Economic Commission for Europe
Inland Transport Committee
World Forum for Harmonization of Vehicle Regulations
Working Party on Brakes and Running Gear
Seventy-fifth session

Geneva, 17–19 September 2013

**Report of the Working Party on Brakes and Running Gear
 on its seventy-fifth session**
Contents

Adopted amendments to ECE/TRANS/WP.29/GRRF/2013/12

Paragraph I, figure B, replaced by:

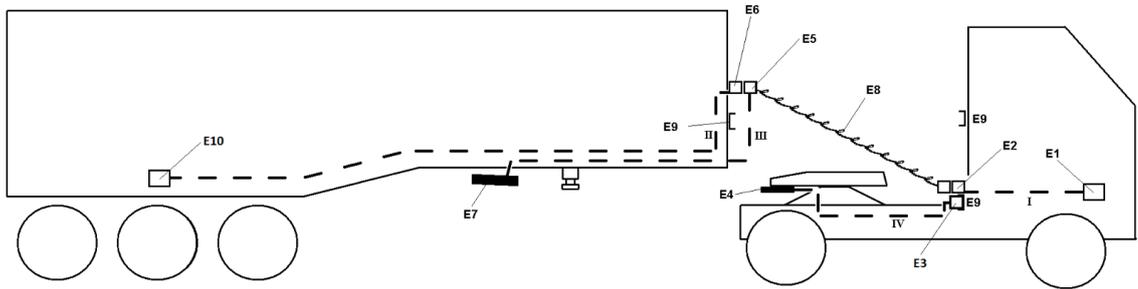
Annex 22,

Appendix 1,

Legend,

Electrical,

For "Cable from E3 to E4", read "Cable from E10 to E6"

For "Cable from E8 to E6", read "Cable from E5 to E7"

For "Cable from E7 to E9", read "Cable from E3 to E4"

Legend,

Pneumatic,

For "Pneumatic coiled tube (control and supply)", read "Pneumatic coupling head on tractor (Control and supply)"
